LARAMIE COUNTY PLANNING & DEVELOPMENT DEPARTMENT

MEMORANDUM

TITLE: PUBLIC HEARING regarding a Subdivision Permit and Plat for Komodo Subdivision, being a replat of Tracts 2, 3, & 4, Titus Tracts, Laramie County, WY.

PZ-21-00318

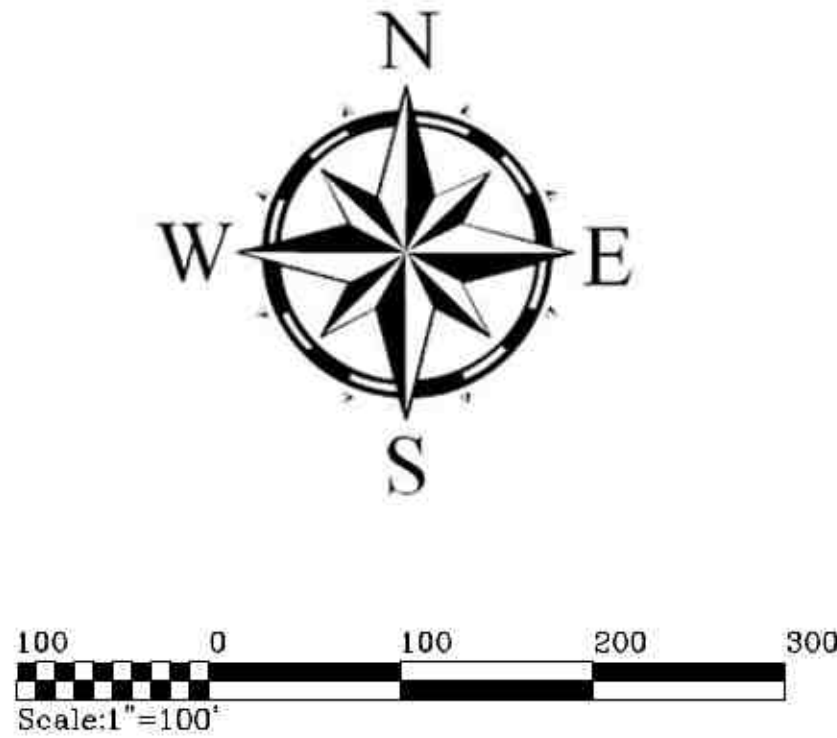
The applicant considers the request to widen the existing Access and Utility easement to eighty (80') feet is excessive, and we suggest widening the design criteria requirements fitting all travelway and easement request in a sixtysix (66') foot wide easement and 64' radius cul de sac. All other easement modifications will be complied with.

We also request that design plans for the access road not be required. This access road is on a straight grade from the cul de sac South to Road 212 and has no cut or fill requirements of any significance. The applicant is a licensed General Contractor with the equipment, resources and experience to construct this road without formal design plans. This would be an unnecessary cost requirement. And the road would be constructed under the inspection of the County personnel.

1. Road Construction design plans for the proposed 66' wide access easement and roadways, that meet County Standards, shall be submitted and agreed upon by the Public Works and Planning Departments, prior to recordation.
